4250607 INLETS, MANHOLES, AND JUNCTION BOXES
COMMENTS FROM INTERNAL/INDUSTRY REVIEW

DATE		BY		DESCRIPTION	
2/20/11	SGA			ADDED OPTIONAL CONCRETE FLUSH SECTION AND NOTES	
STATE OF FLORIDA		DEPARTMENT OF TRANSPORTATION		ROAD NO.	
COUNTY		LEON		FINANCIAL PROJECT ID	
SHEET NO.		UTV-1		WATER VALVE BOX & SEWER MANHOLE ADJUSTMENT

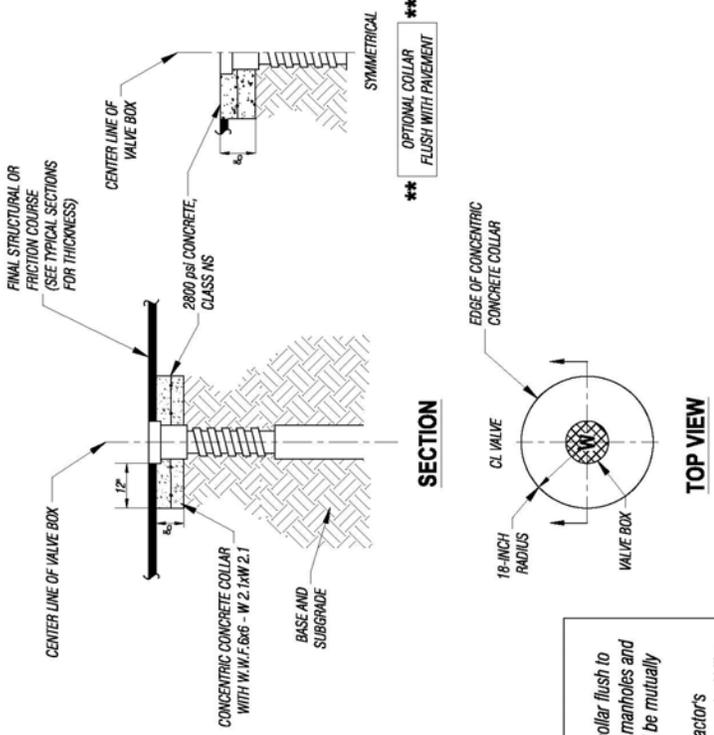
Attached is a drawing provided to you as "industry comment" to FDOT's proposed amendments to 2010 UAM, Spec Section 425, and Index 201. This is a draft detail that I put together last year, before the FDOT ban on concrete collars in state highway pavements. For your consideration.

Response: Thank you.

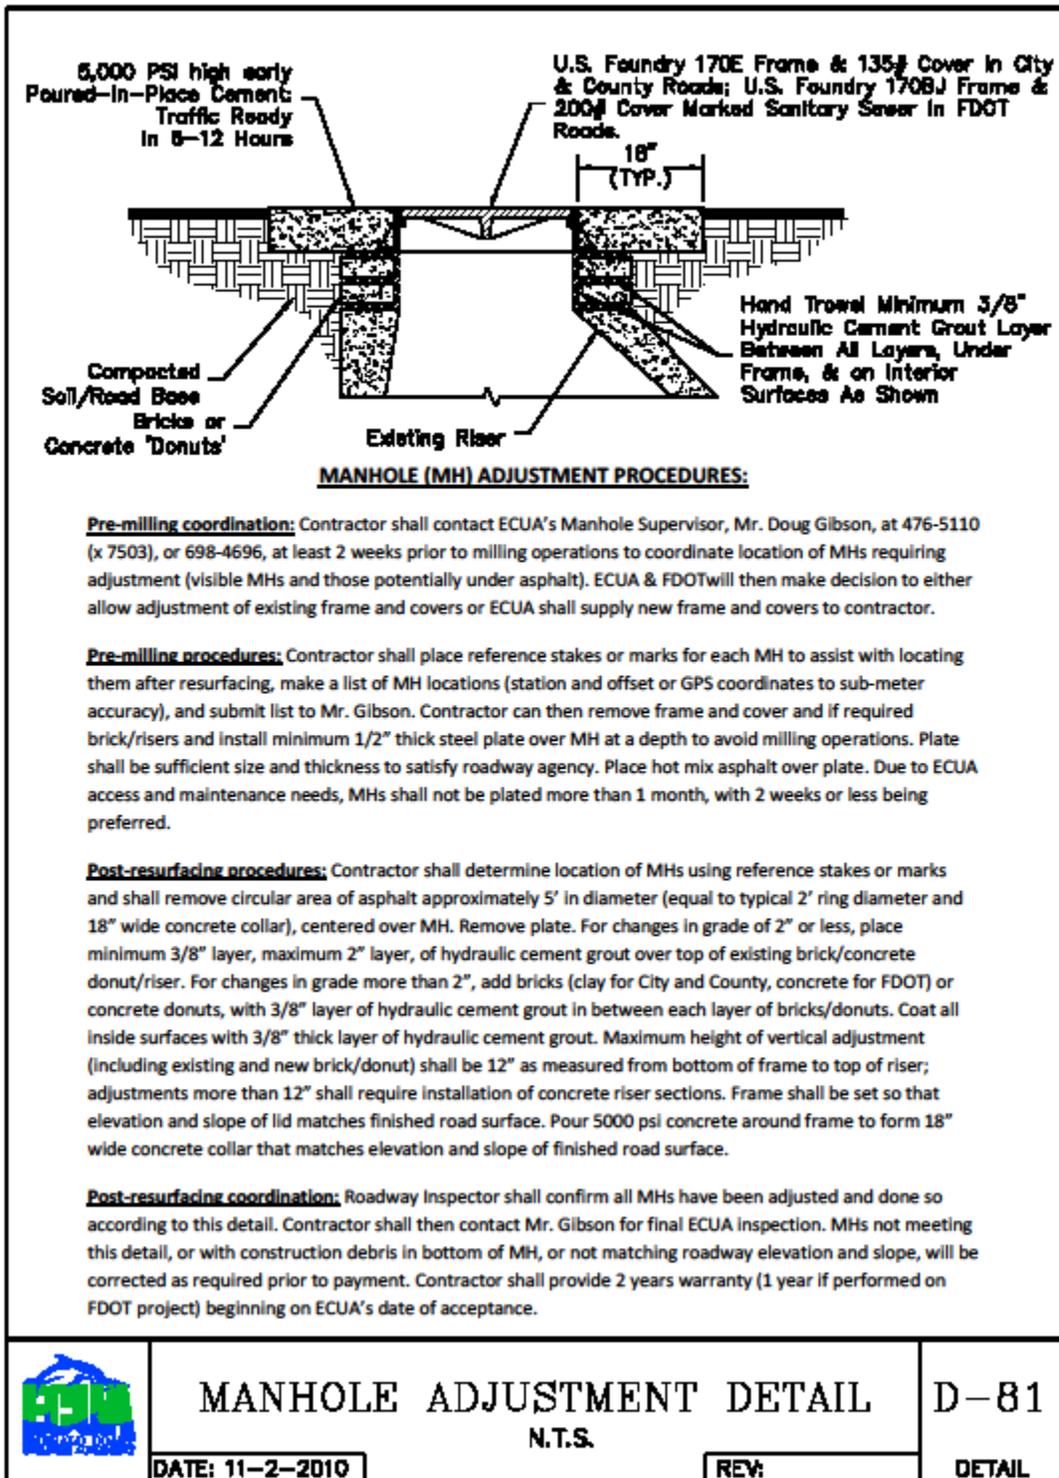
3. We actually have developed a detail (see below, D-81 Manhole Adjustment Detail.pdf) to try and standardize the best means and methods we know. As you can see, it emphasizes hand spread mortar layers under and between bricks and frames. This is critical because rebuilding the section from the riser to the frame needs to be seen as a structural course, holding the frame in place, and eliminating shifting and concrete cracking.

6. For simplicity, perhaps a detail similar to the one attached at the end of this document (see 5-4-12 comment above, #3) are what is needed in the FDOT Standard Drawings. This puts everything a contractor would need to know in one detail, not on several details and/or buried in the specs.

Response: This is beyond the scope of this revision. The intent is that the final surface layer match the existing pavement type, we are not changing the method for adjusting manholes. No change made.

Response: The intent is that the final surface layer match the existing pavement type, we are not changing the method for adjusting manholes.
No change made.
